# **SERVICE INFORMATION**

## **NO. SI 50-006**

Safe Flight Service Bulletin for Lift Transducer C-99707-2

Moisture ingress on certain lift  
transducer main connections

**Figure 1**

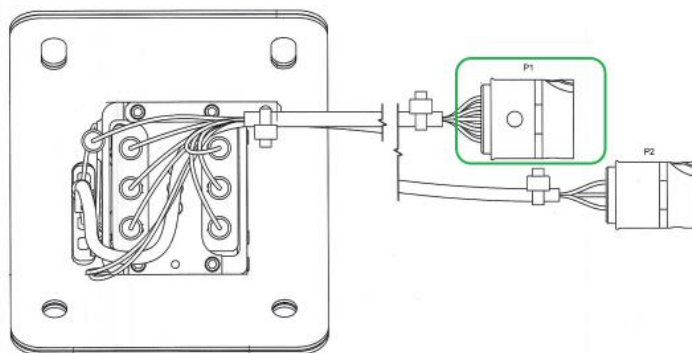
- 1.) The moisture ingress prone component, P1 interface connector, is located at the end of the pigtail of Lift Transducer, P/N C- C-99707-2 (See Figure 1) .

**Figure 2**

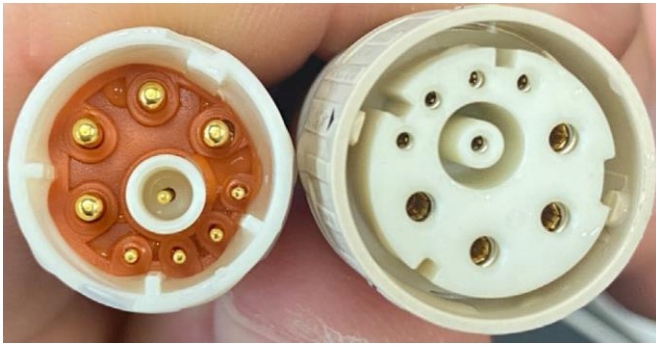
- 1.) Disconnect the mated P1 connector shells, Amphenol PCD P/N SJS860900 and P/N SJS860910.
- 2.) Thoroughly inspect the faces of each (see Figure 2) for evidence of any debris.
